NORTH LONDON WASTE AUTHORITY  
NORTH LONDON HEAT AND  
POWER PROJECT  
EN10071

STATEMENT OF COMMON GROUND:  
LONDON BOROUGH OF ENFIELD

AD03 . 04

Revision 1 |

Figure 1: Location of SuDS surface feature

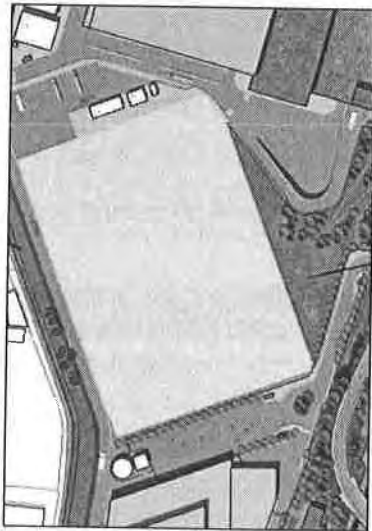
3.25.2 It is agreed that due to the nature of the waste management use and the requirement to comply with pollution prevention requirements (e.g. the Environment Agency's Fire Prevention Plan) there is limited opportunity for surface SuDS features at the Application Site. The use of permeable paving in the staff and visitor parking area is agreed, as is the approach to green and brown roofs as set out in the Application. A piped and tanked drainage system with oil interceptors is agreed as an appropriate approach to surface water management. It is also agreed that a surface SuDS feature will be provided in the landscape area to the east of the existing EfW, shown in Figure 1. This commitment has been added to the updated Environmental Commitments and Mitigation Schedule (AD06.03) submitted at Deadline 6.

Area where a SuDS surface feature would be located (subject to detailed design)
